PCN No#: 030422-1

PCN Title: MCC Introduces Auto-Assembly Process for SMA6J Series.

PRODUCT CHANGE NOTICE

Table A - Appearance comparison(SMA6J18AHE3-TP)

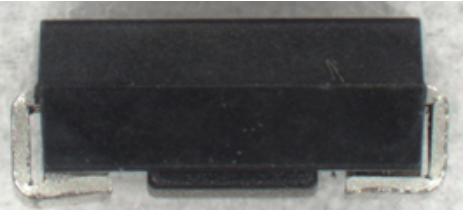
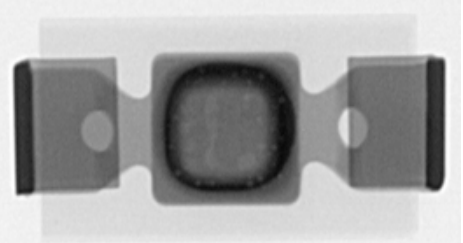
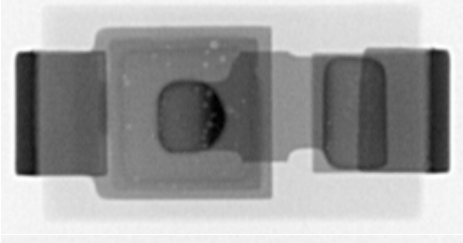
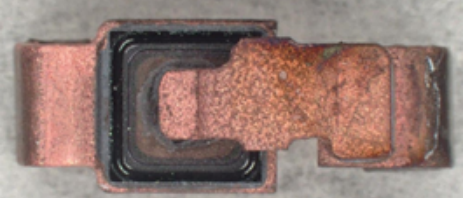
Current appearance and structure	New appearance and structure
